Common Structural Rules for Bulk Carriers and Oil Tankers

Corrigenda 1 to 01 January 2021 version

Notes: (1) This Corrigenda enters into force on 1st July 2021

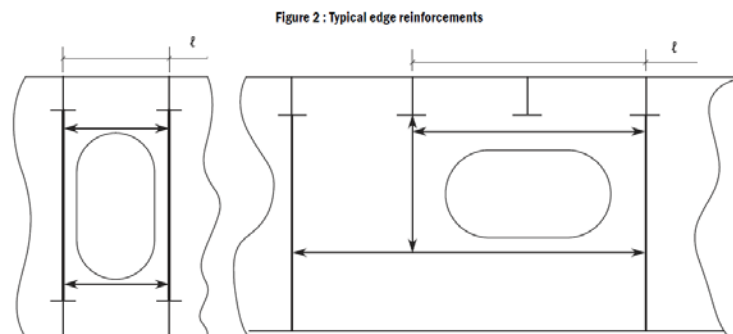
When fitted as shown in Figure 2, the depth of web, h_w in mm, of edge stiffeners in way of openings is not to be less than:

ℓ : ~~Length of edge stiffener in way of opening, in m, as defined in Figure 2.~~

Figure 1: Example of extension to lower edge of deck beams of longitudinal coaming by fitting a hatch side girder

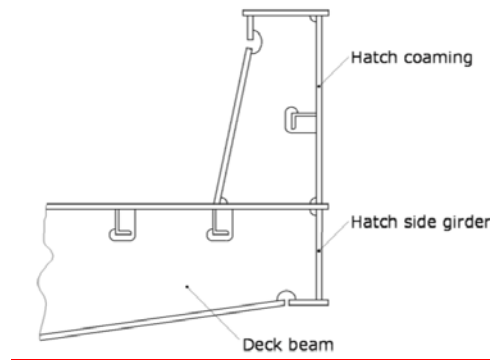
Longitudinal coamings are to be vertically extended at least to the lower edge of deck beams or hatch side girders below deck are to be fitted in line with longitudinal coamings. Extended coaming plates are to be flanged or fitted with face bars or half-round bars at the level of lower edge of the deck beams. Figure 1 gives an example.

- Where they are not part of continuous deck girders, the lower edge of longitudinal coamings including below deck structure as an extension measure above are to extend for at least two frame spaces beyond the end of the hatch openings.
- Where longitudinal coamings they are part of continuous deck girders, their scantlings are to be as required in Pt 1, Ch 6, Sec 6 and Pt 1, Ch 8, Sec 3.
